McGUIRE NUCLEAR STATION, UNIT 1

AMENDMENT TO FACILITY OPERATING LICENSE

Amendment No. 141
License No. NPF-9

ATTACHMENT TO LICENSE AMENDMENT NO. 141

Figure 2.1-1
 REACTOR CORE SAFETY LIMITS - FOUR LOOPS IN OPERATION

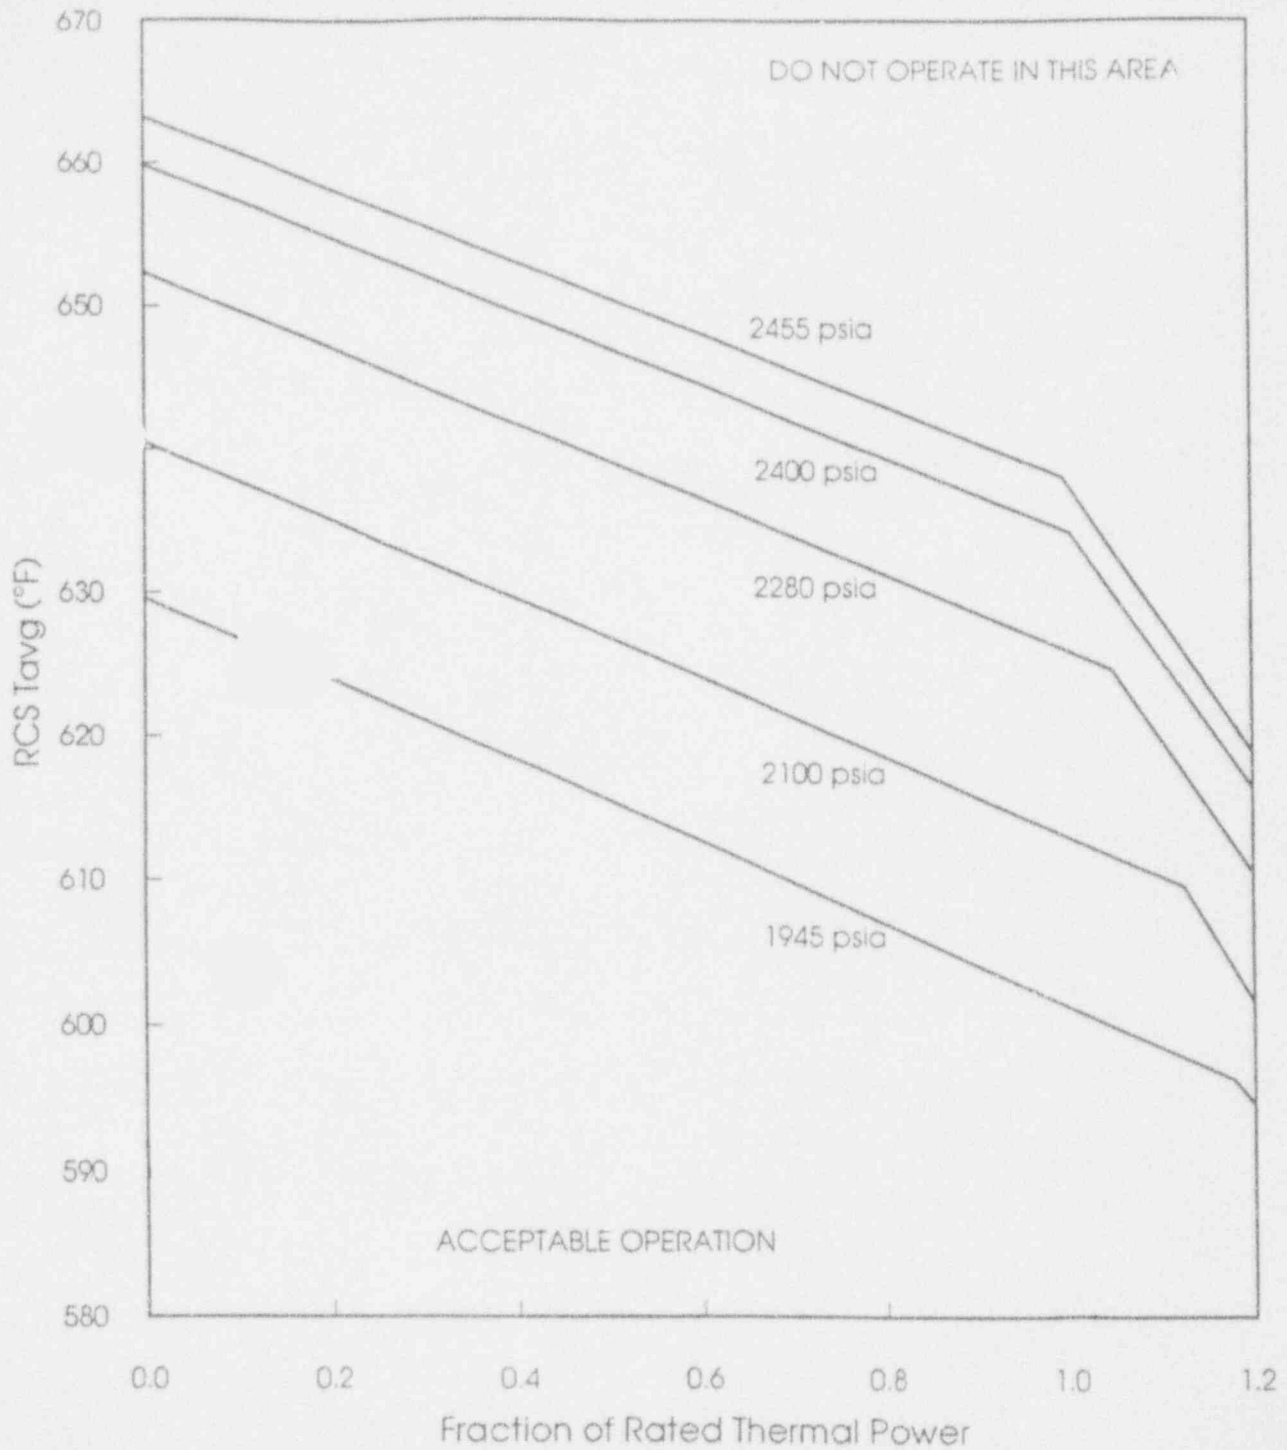
Replace the following pages of the Appendix "A" Technical Specifications with the enclosed pages. The revised pages are identified by Amendment number and contain vertical lines indicating the areas of change.
